CITY OF ALBUQUERQUE

Planning Department
Alan Varela, Director

April 13, 2023

Re: Sawmill Tract J
800 20TH St. NW
Traffic Circulation Layout
 Engineer's Stamp 02-28-23 (J13-D076B)

KEYED NOTES

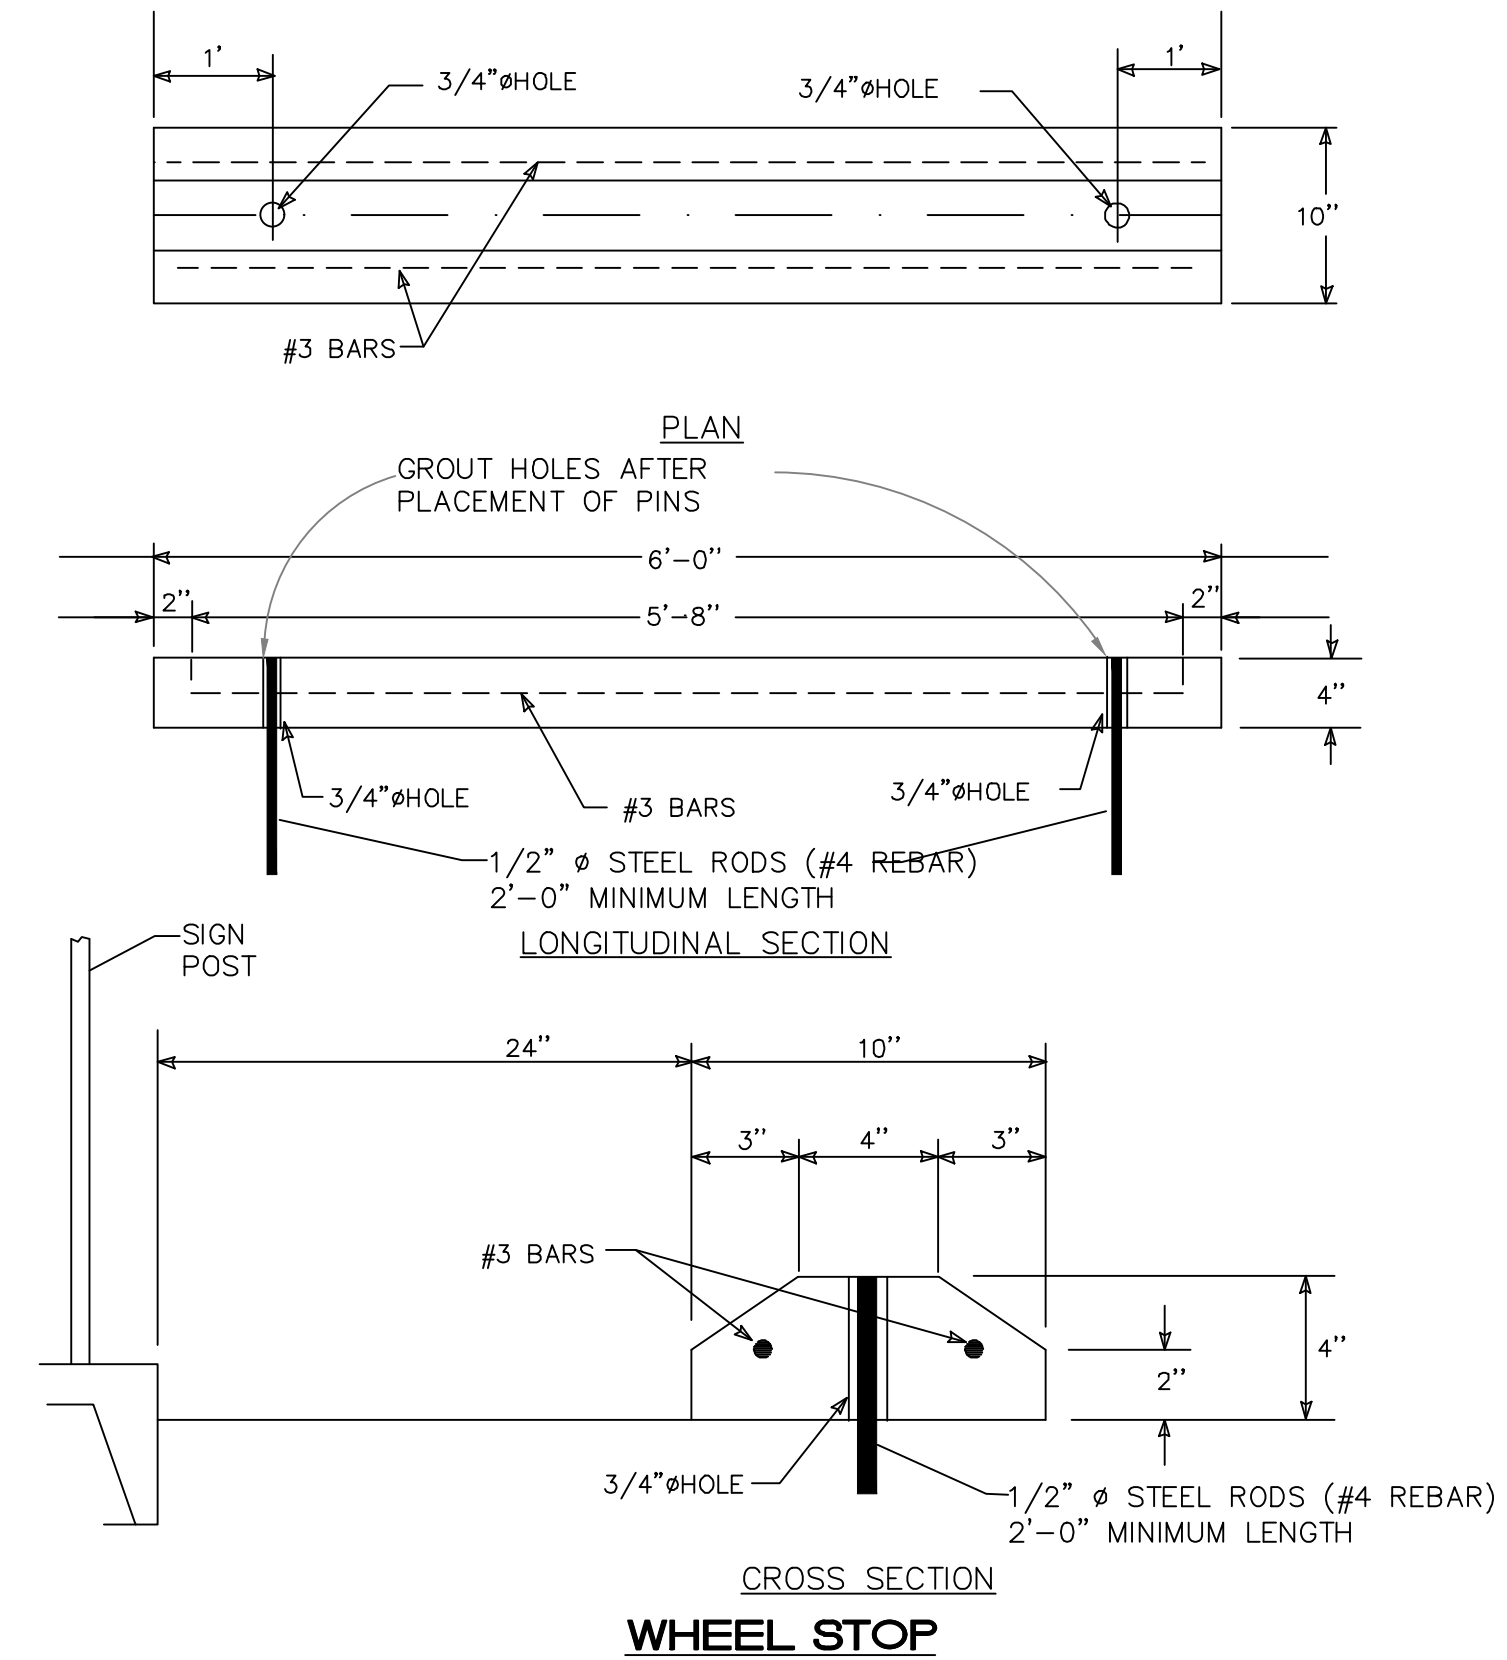
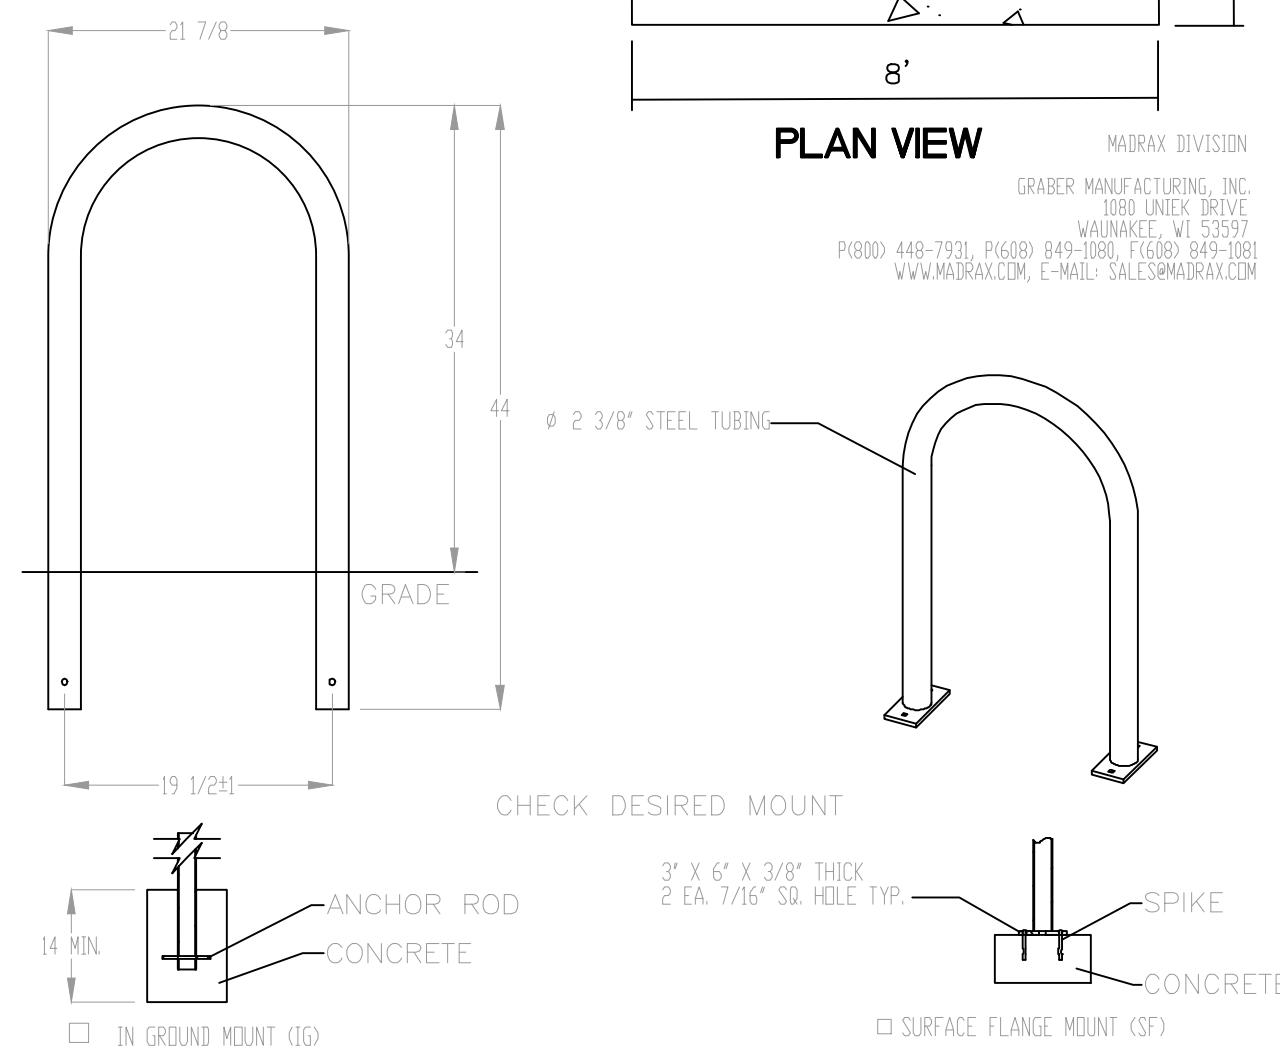
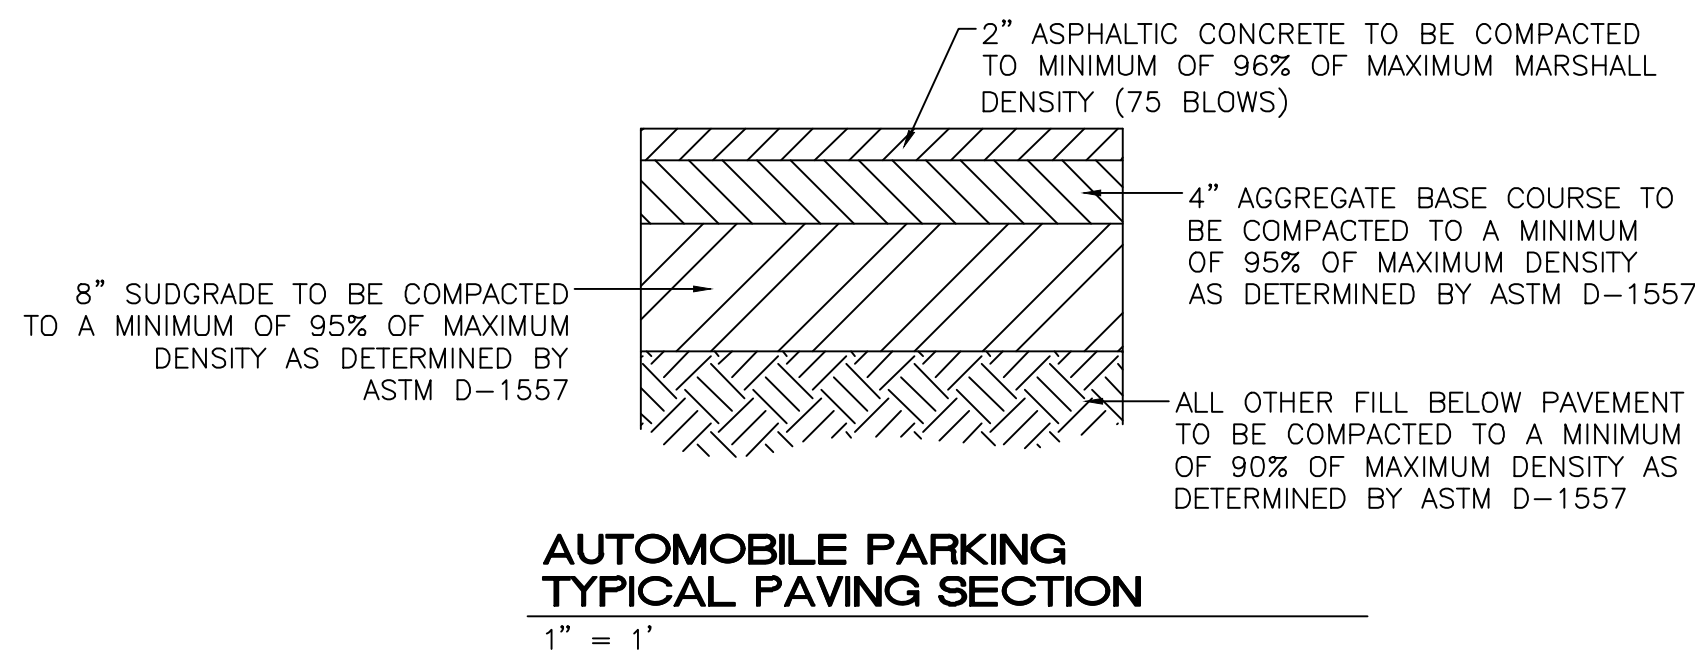
1. Identify all existing access easements and rights of way width dimensions.
2. Is there any basement or second floor parking spaces? If so, please provide a site plan showing all the proposed parking spaces, details and dimensions.
3. The site access's east leg appears to encroach with the adjacent property. Please provide the adjoining property owner agreement.

5. Please provide all proposed drive aisles width.

6. Please provide ADA aisle for all the proposed ADA parking spaces.

7. The ADA accessible spaces must include an access aisle. Van accessible aisles should be 8ft wide; all others should be 5ft wide.
8. The ADA access aisles shall have the words **"NO PARKING"** in capital letters, each of which shall be at least one foot high and at least two inches wide, placed at the rear of the parking space so as to be close to where an adjacent vehicle's rear tire would be placed. (66-1-4.1. B NMSA 1978)
9. ADA curb ramps must be updated to current standards and have truncated domes installed.
10. Please show on the site plan the location the proposed Motorcycle parking spaces.
11. The pavement marking "MC" should be shown in the opposite direction for motorcycles entering the parking space.
12. A 5 ft. keyway is required for dead-end parking aisles. Please show this dimension on

the site plan.

13. Per the IDO, a 6 ft. wide ADA accessible pedestrian pathway is required from the public sidewalk to the building entrances. Please clearly show this pathway and provide details.

14. Per DPM, a 6 ft. wide ADA accessible pedestrian pathway is required from **EACH** ADA parking stall access aisles to the building entrances. Please clearly show this pathway and provide details.

15. Define ADA pathway by labeling ramps or flush pavement.
16. ADA accessible pedestrian pathway should not be placed behind parking space or adjacent to a vehicular way. Vehicle and pedestrian/wheel chair conflicts should be avoided as much as possible.

17. Curbing should be installed to delineate landscape, parking, and pedestrian ways and identify points of access. Please call out detail and location of barrier curb.

18. Refuse vehicle maneuvering shall be contained on-site. The refuse vehicle shall not back into the public right of way.; provide a copy of refuse approval.

20. It is not apparent what type of pavement surface is being proposed. A hard driving surface will be required as part of this proposed project for parking area and drive aisles.

21. Please specify the City Standard Drawing Number when applicable.
22. Add a note stating "All broken or cracked sidewalk must be replaced with sidewalk and curb & gutter." A build note must be provided referring to the appropriate City Standard drawing.
